## Proposal for amendments to Regulation No. 107 (M<sub>2</sub> and M<sub>3</sub> vehicles)

### Submitted by the expert from Sweden \*

The text reproduced below was prepared by the expert from Sweden to introduce fire suppression systems for buses and coaches upon detection of fire in the engine and/or heater compartment. It supersedes Working Document ECE/TRANS/WP.29/GRSG/2014/6. The modifications to the current text in ECE/TRANS/WP.29/GRSG/2014/6 are marked in red and deleted information are marked in red with strikethrough.

**Figure 1**  
**Test fire positioning, view from the front side**

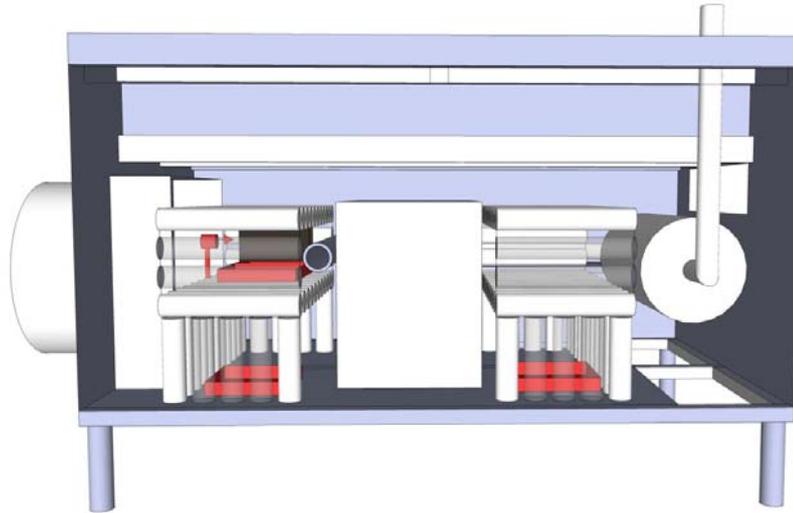
<i>Test fire</i> (see Table 5 in appendix 1)	<i>Description</i>	<i>Coordinates [x; y; z]</i> (see Figure 1 in Appendix 1)
#5	Spray fire (4.5 bar, 0.73 kg/min)	[0.37; 0.70; 0.46]
#1	Pool fire <del>300</del> 200 mm × 300 mm	[0.37; <del>0.47</del> 0.57; 0.36]
#2	Pool fire 300 mm × 300 mm and 2 fibreboards	[0.37; 0.77; 0.36]
#1	Pool fire 300 mm × 300 mm	[0.37; <del>0.13</del> 0.23; 0.00]
#1	Pool fire 300 mm × 300 mm	[1.54; 0.13; 0.00]
